Emerald Parkway Bridge Parking Lot Project

Addendum #1

January 30, 2014

DATE: 09/18/2006
 CITY OF DUBLIN, ENGINEERING
 STANDARD DRAWING
COMBINATION CONCRETE CURB & GUTTER
 SHEET 1 OF 1 DWG. NO. RD-02

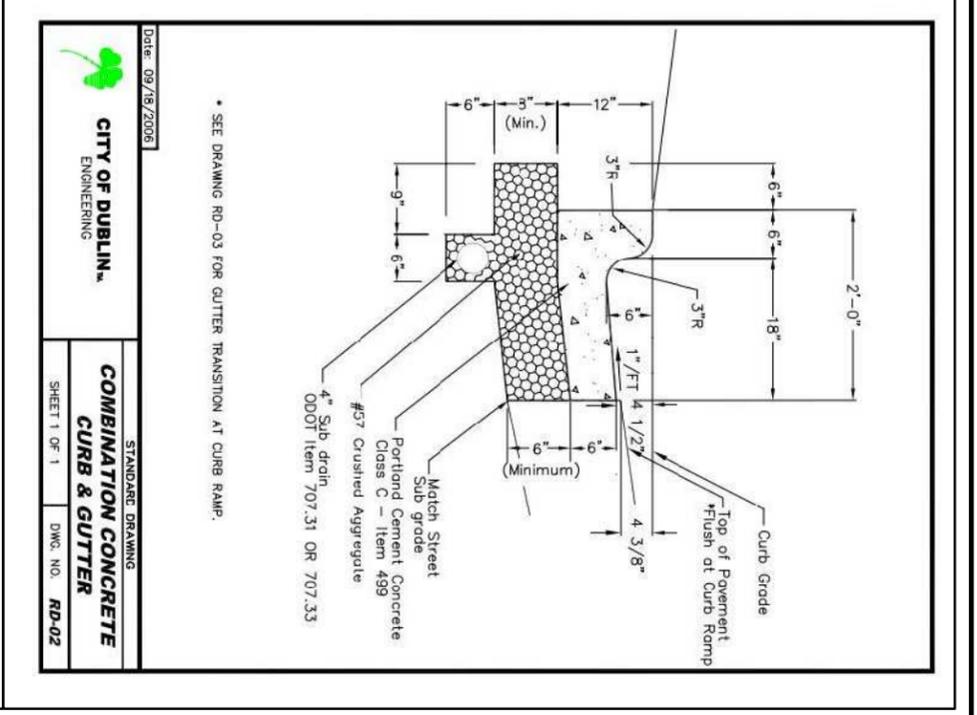
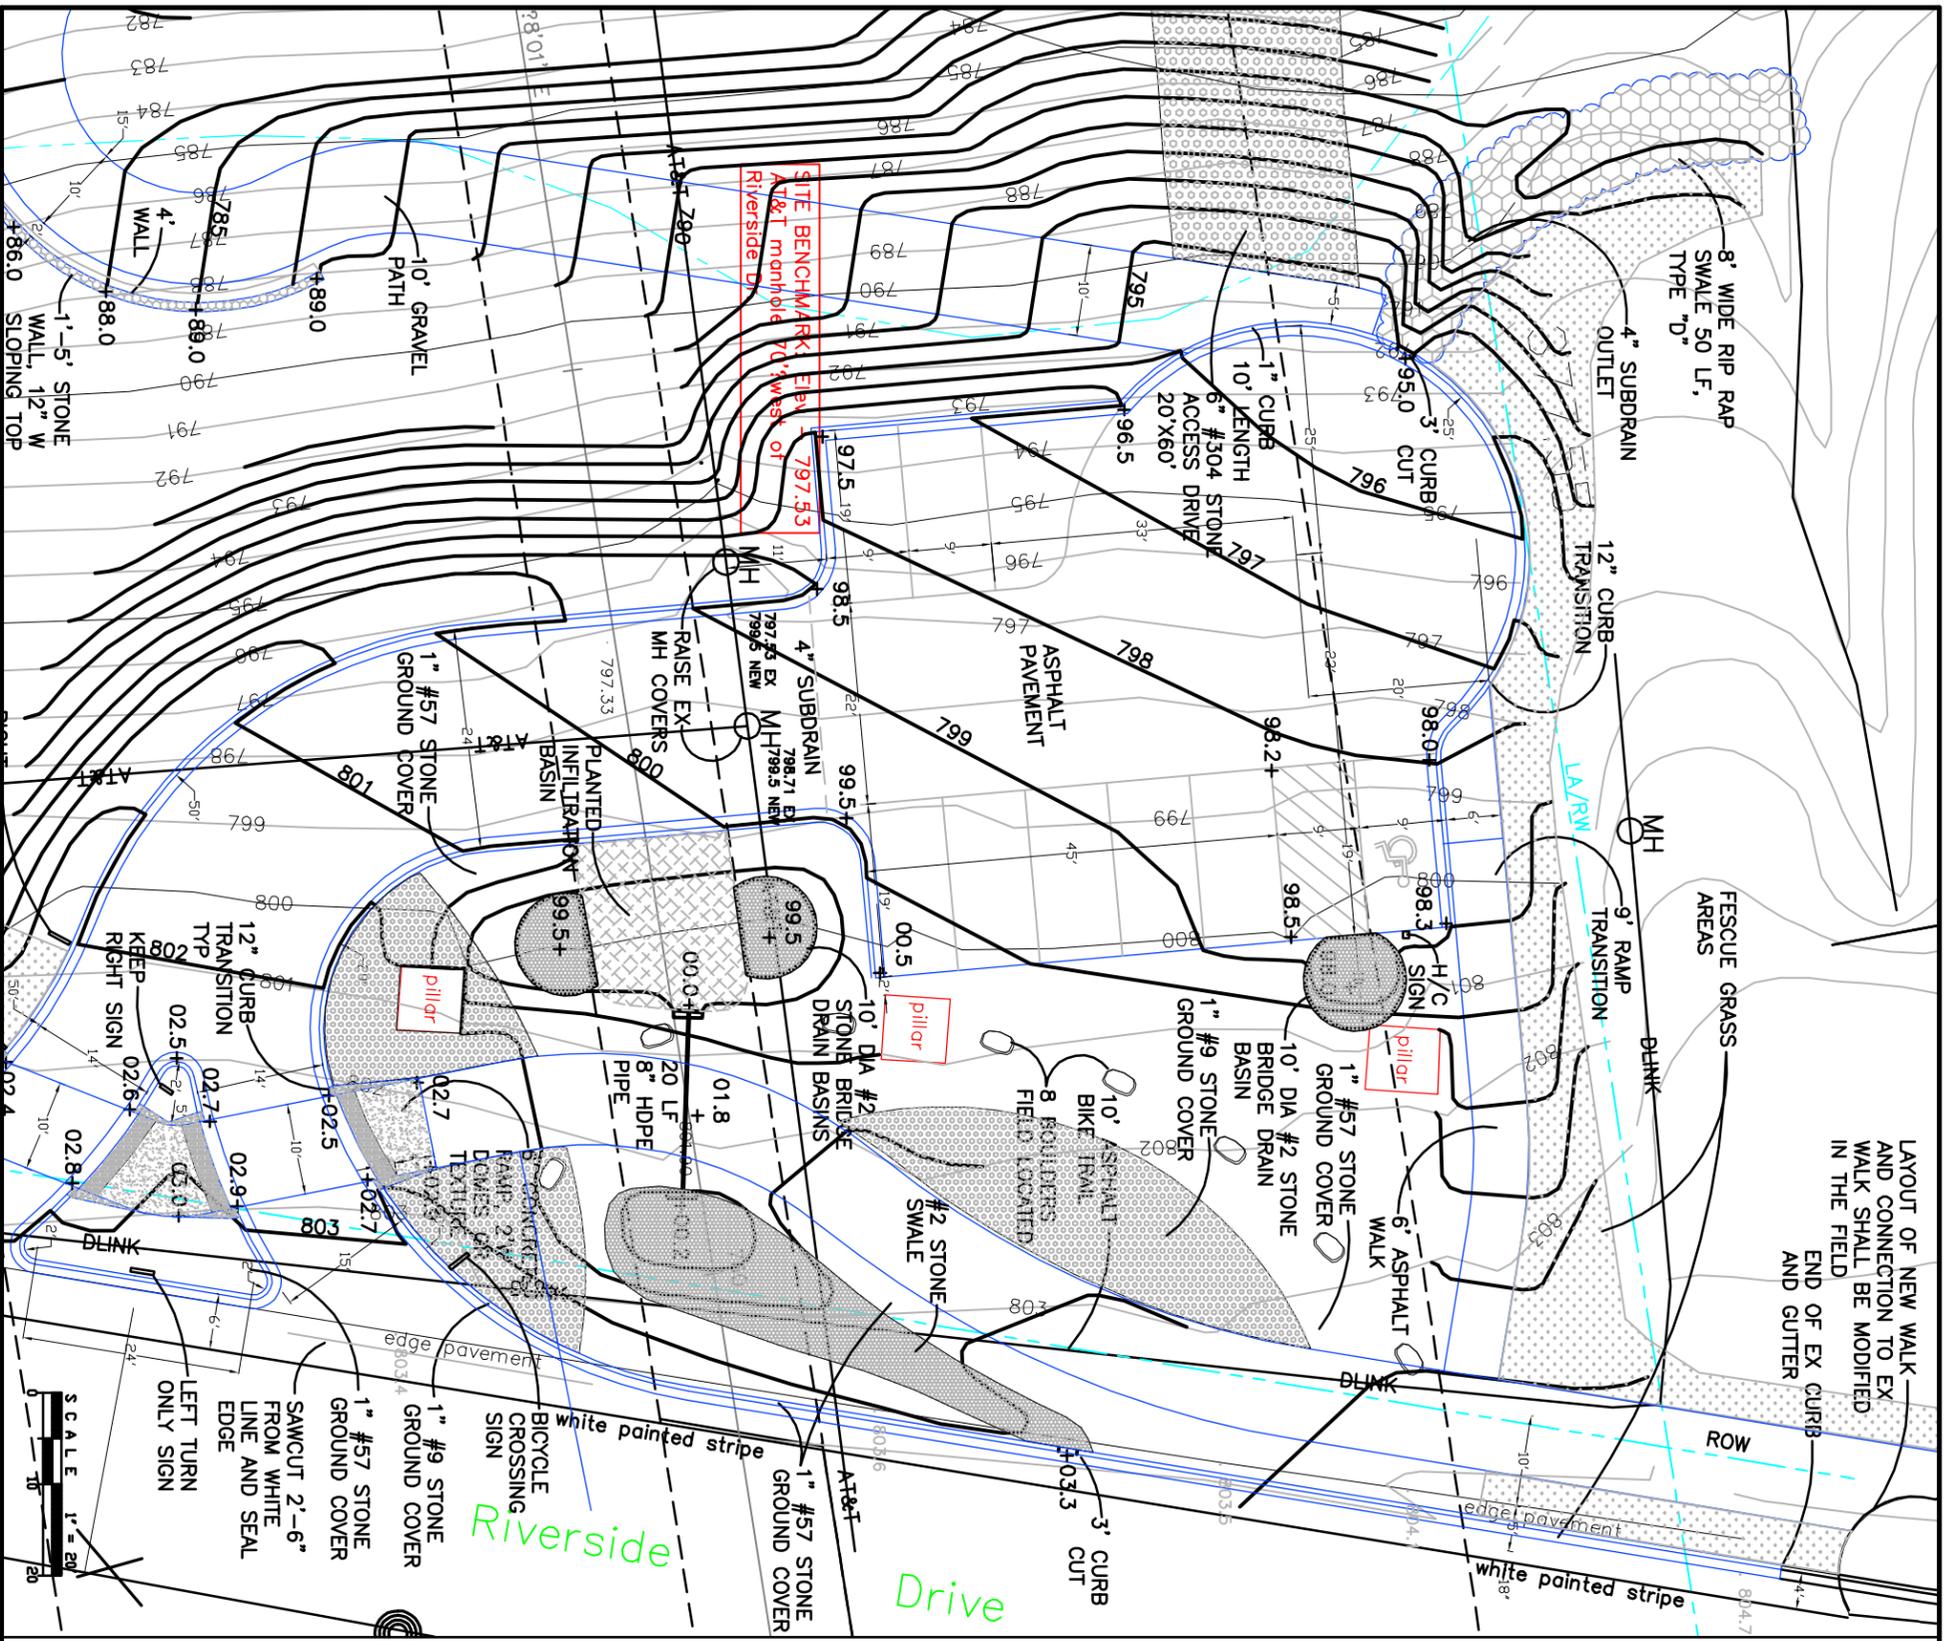
Some of the approval stamps cover details. Impacted: typical gravel trail, combination curb and gutter

Item #1: The Emerald Parkway Bridge Parking Lot plans are being re-issued under this cover. The approval stamps, that were blocking detail information, have been removed. The plans can now be printed in black and white. Some pages are still more legible in color.

(A) SINGLE WING ROCK VANE
NOT TO SCALE

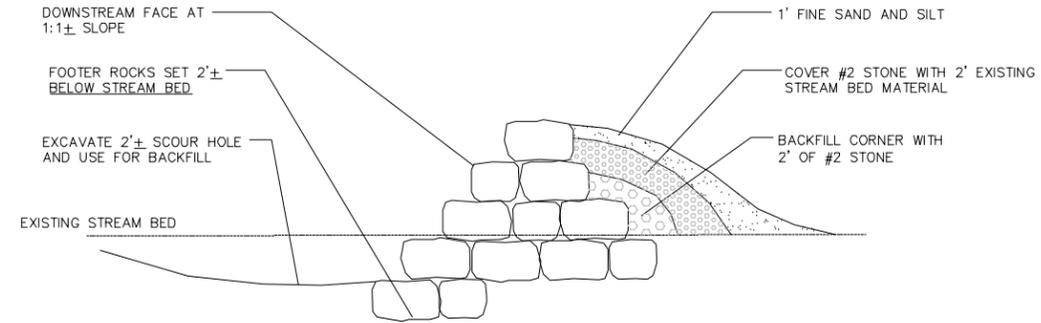
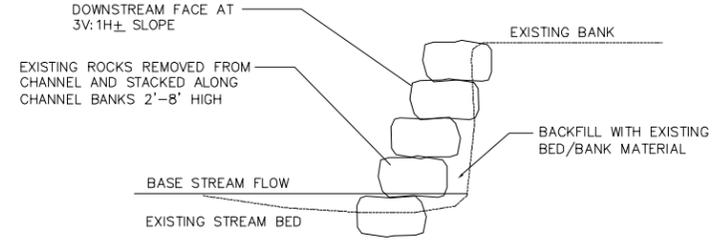
The wing rock isn't called out in exact dimensioned. Scott said that the overall dimension is called out, but that the wings were very dependent on the rock size and shapes. He will work with the contractor in the field for rock placement.
